THE VILLAS AT CLAREMONT RANCH

TRACT A & G CLAREMONT RANCH FILING NO 7

PUD DEVELOPMENT PLAN & PRELIMINARY PLAN

PUD V_1 redlines.pdf Markup Summary 2-19-2021

DESIGNED BY: DLM	DRAWN BY: DBM
SCALE: N/A	DATE: 11/17/20
JOB NUMBER: 16-102	SHEET: OF
PRELIMINARY UTILITY PLAN

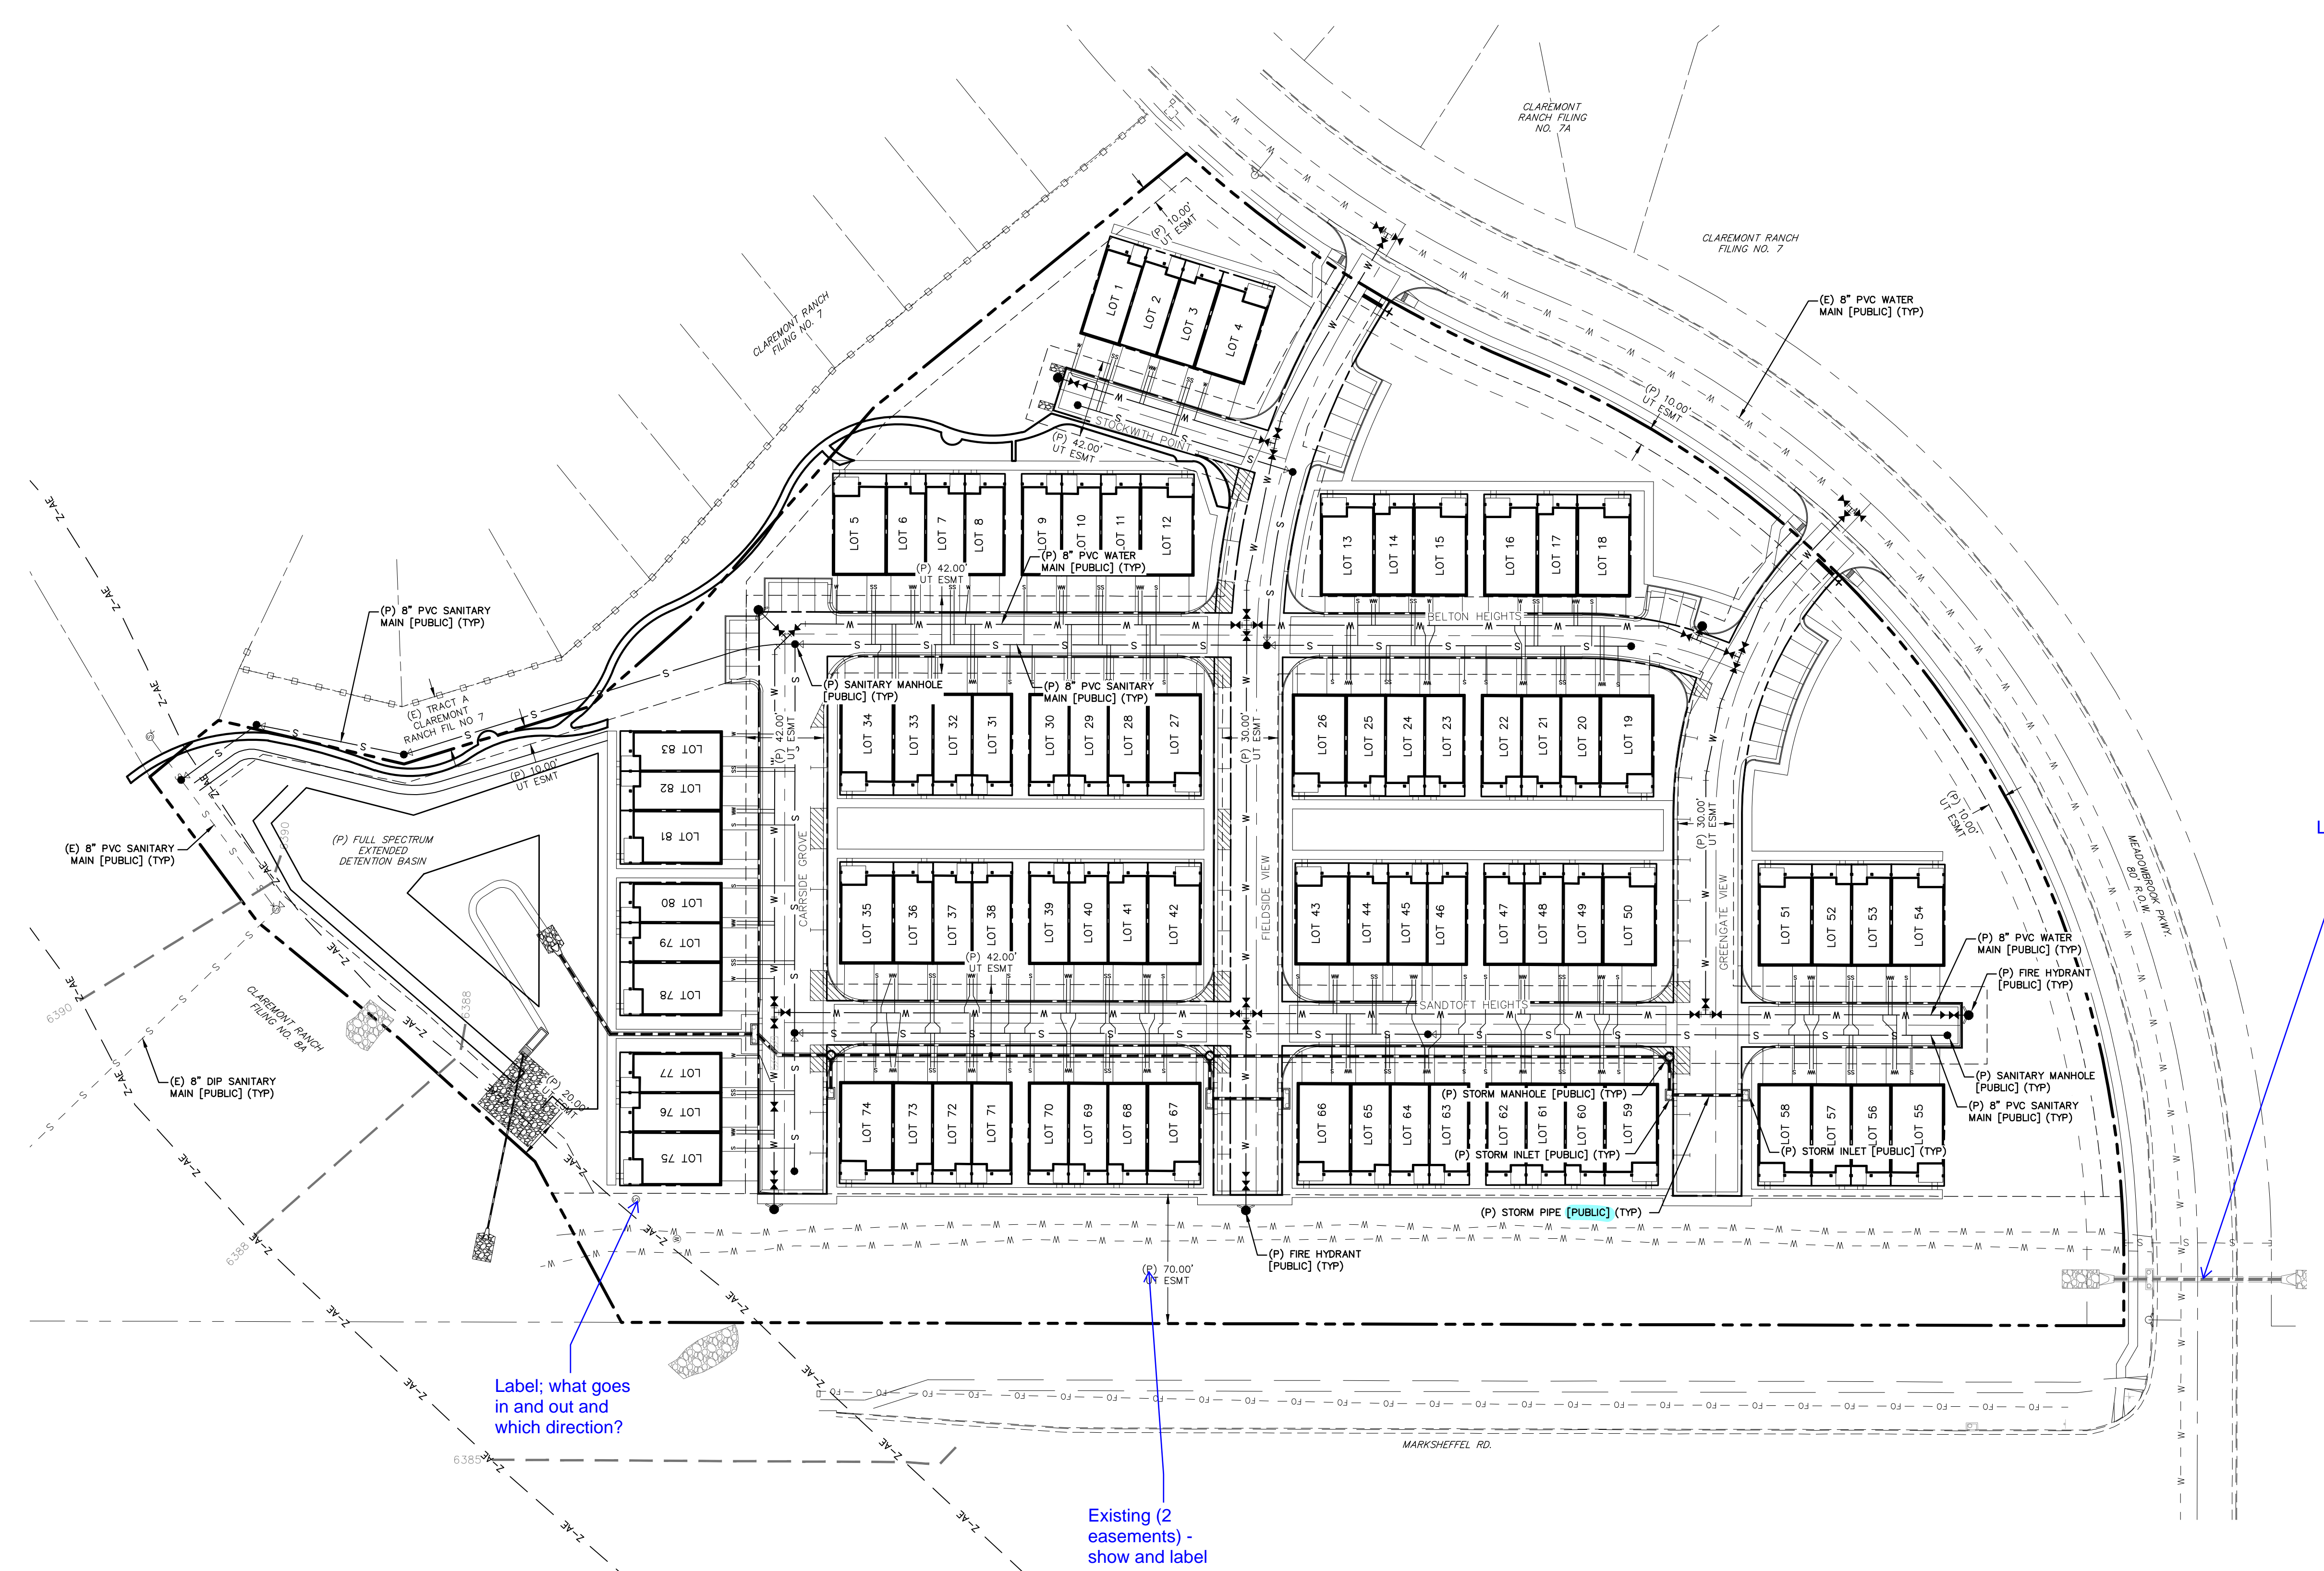
Label

Label; what goes in and out and which direction?

Existing (2 easements) - show and label

Final Landscape Plan

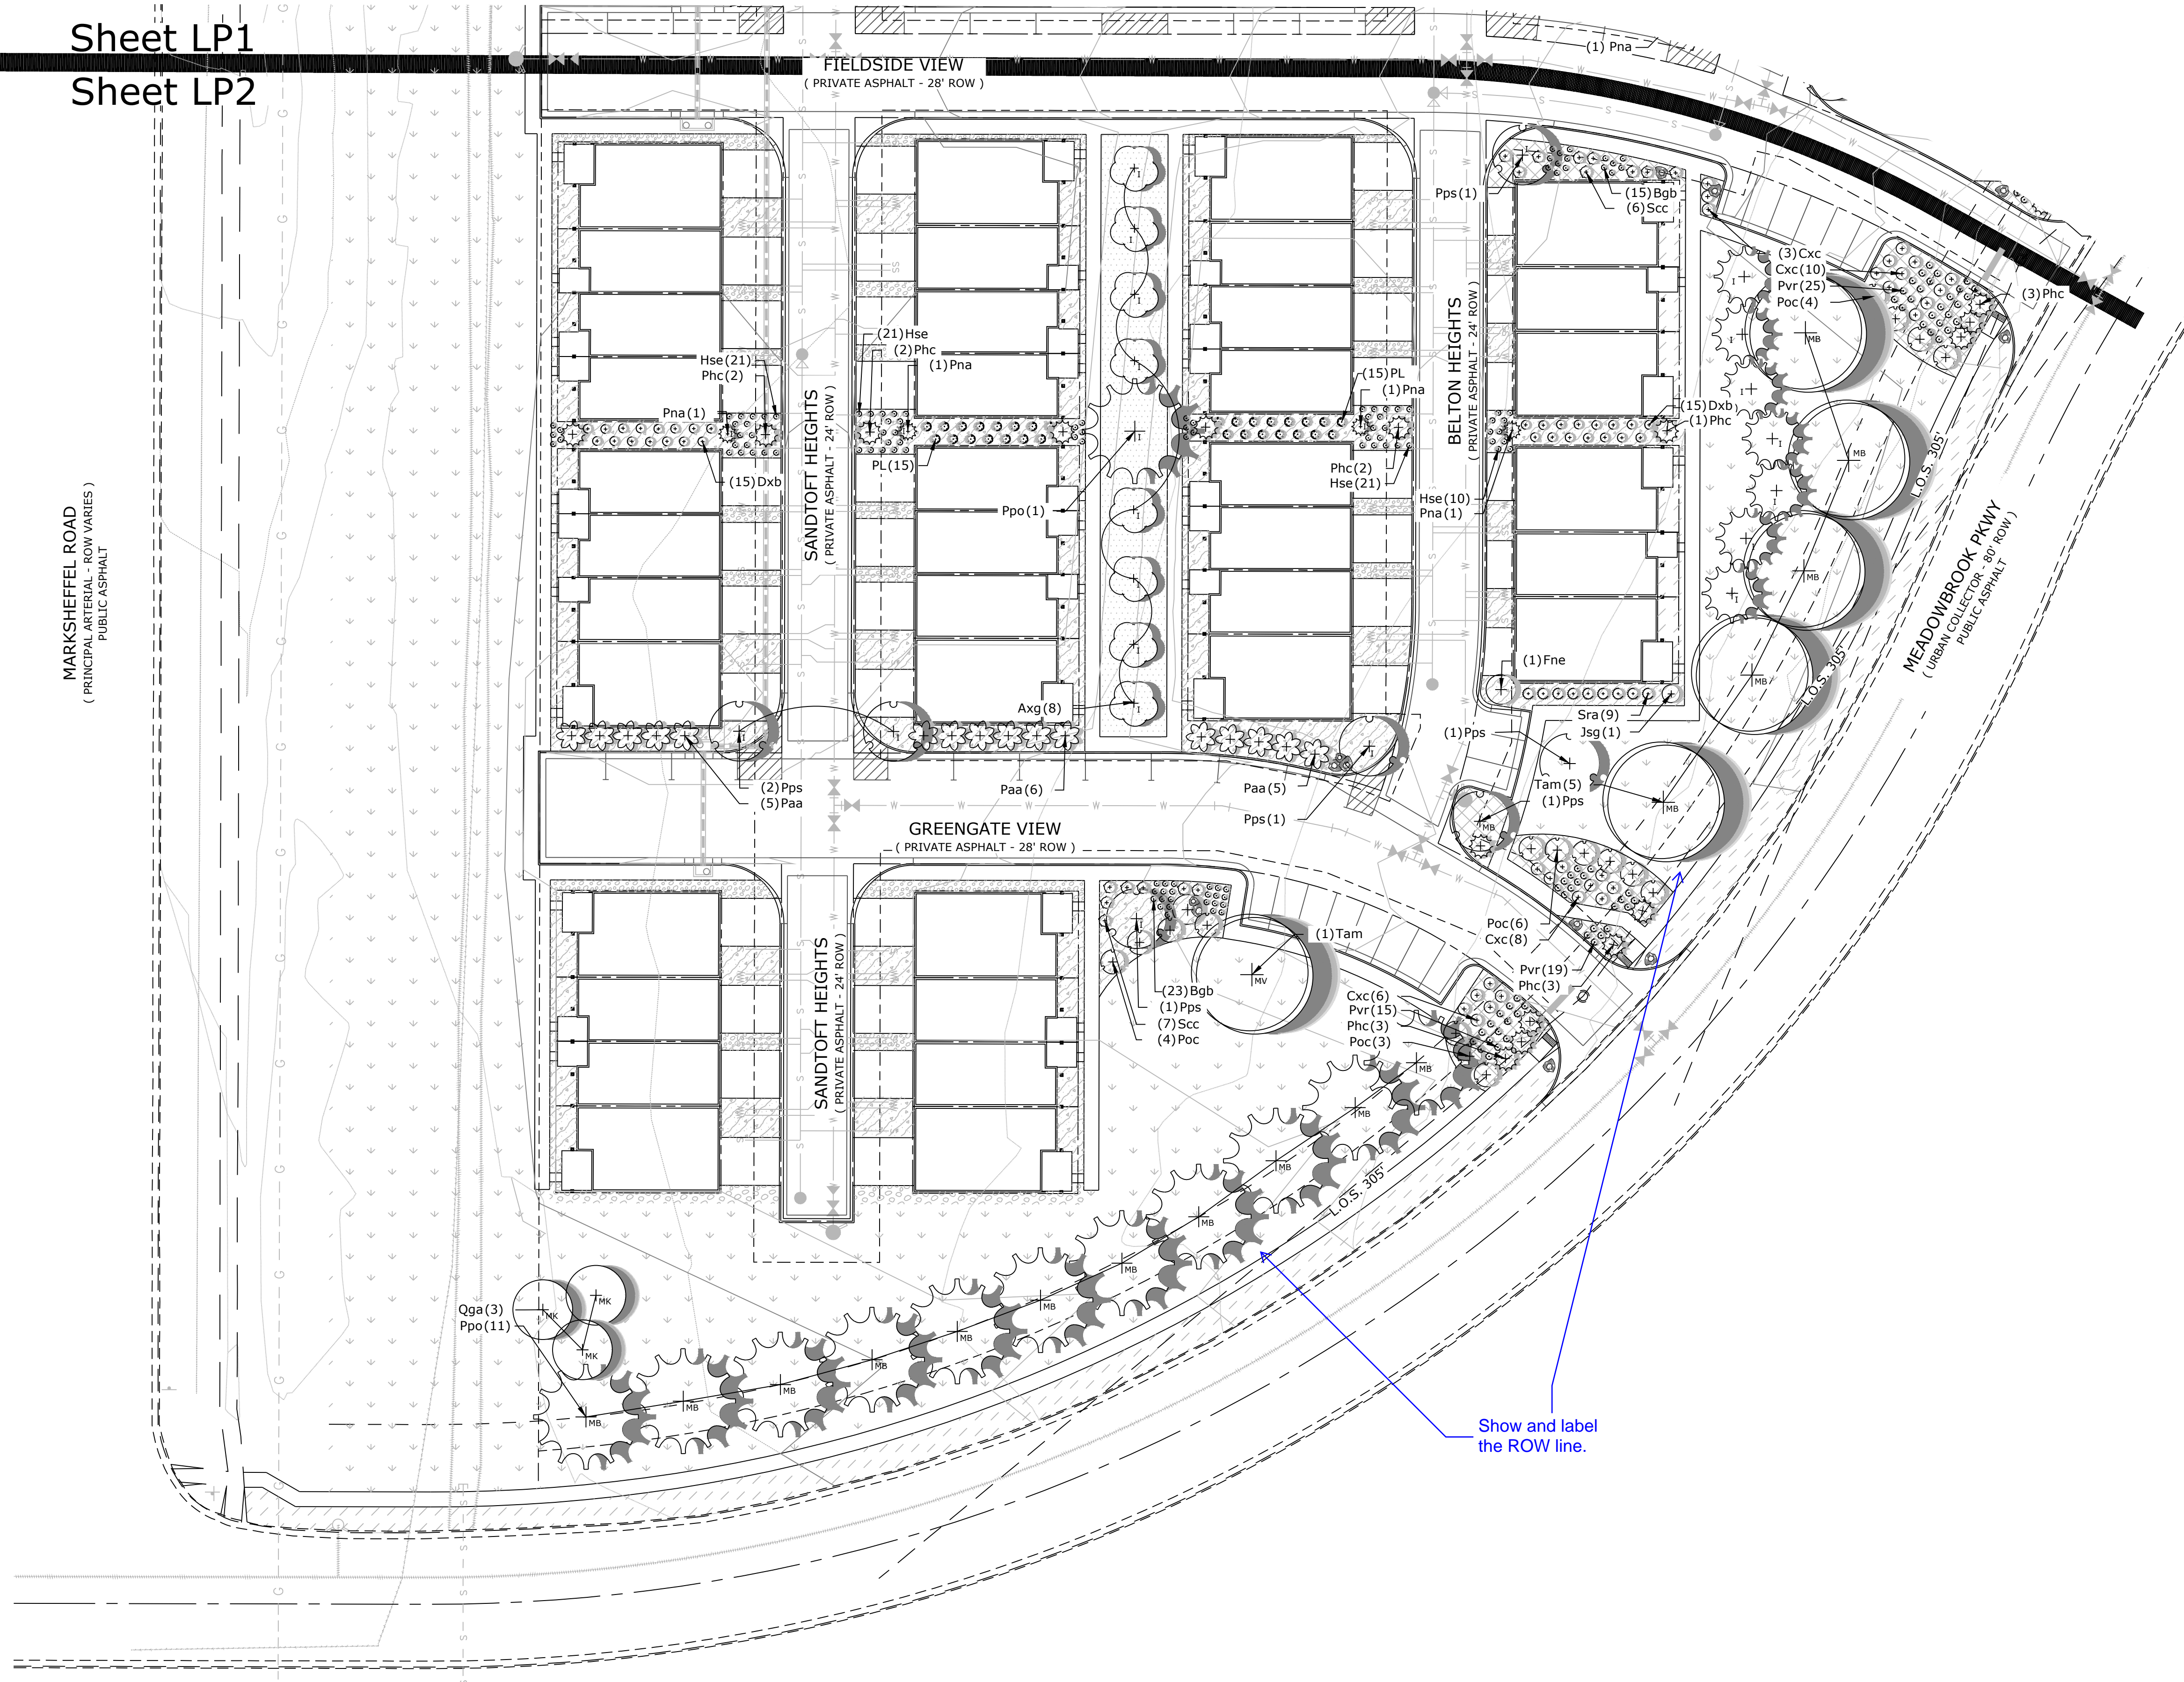
see checklist please
for missing items

trail width, material,
installed by who,
maintained by ?

add lot numbers and
tract letters

show all lot lines,
easements and tracts
on plan clearly.
Some landscape
looks like it may be in
lots when lot lines are
depicted- who will
maintain is?
